**Date:** February 3, 2026  
**Prepared by:** Meaghan Truman, Senior Environmental Planner  
**To:** Albert Armijo, City of Perris  
**Site:** Harvest Landing Retail Center and Business Park Project  
**Subject:** **Responses to Californians Allied for Responsible Economy (CARE CA), Letter L5**

**Re: Comments on Planning Commission Agenda Item 6.A. and the Final Environmental Impact Report for the Harvest Landing Retail Center & Business Park Project (SCH No. 2024080337)**

**Figure 3: Rates of Valley Fever In Riverside County 2019-2023**

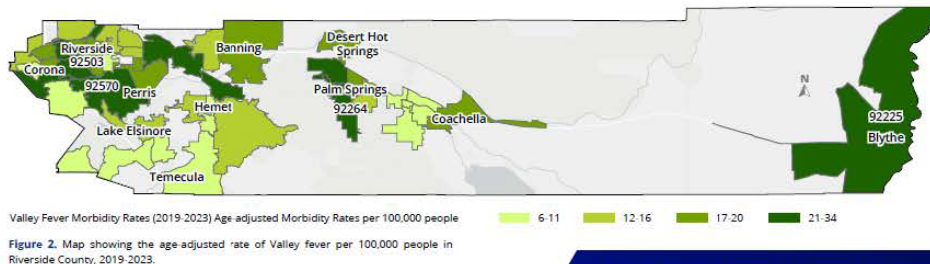
The City’s response in Comment O2.24/O2.51 states that the Valley Fever rate in Riverside County is 19.0 for every 100,000 people in 2024. As I pointed out in the comments provide previously, based on a study by the University of California Riverside (UCR) (see figure below) it is evident that Mead Valley and Perris are hot spots for the County of Riverside with rates of Valley Fever at 21 per 100,000 to 34 per 100,000. This rate is the highest in Riverside County and represents a significant threat to the health of construction workers at the Project Site and residents adjacent to the Project Site

Given that there is no minimum threshold concentration for exposure to Valley Fever spores, any level of exposure could pose significant health risks to construction workers and nearby residents. The City must disclose this potentially significant impact and require effective mitigation measures

**Response L5.16:** As discussed above in Response L5.6. California Department of Public Health data shows that the rate of Valley Fever in Riverside County was 465 residents overall for the entire county in 2024 which equates to a rate of approximately 19.0 for every 100,000 residents.<sup>2</sup> For context, this is an extremely low rate of occurrence in general as well as compared to counties where Valley Fever is more prevalent: the highest is Kern County (3,873 cases) and the second highest is Los Angeles County (1,749 cases). Therefore, in accordance with the CEQA Guidelines, it is appropriate for the City not to focus the Draft EIR's analysis on this issue. Further, as stipulated by a footnote to the comment, Riverside County Valley Fever incidents have not yet reached 20 per 100,000 persons per year. Therefore, the proposed Project would not be required under state law to mitigate impacts related to Valley Fever.
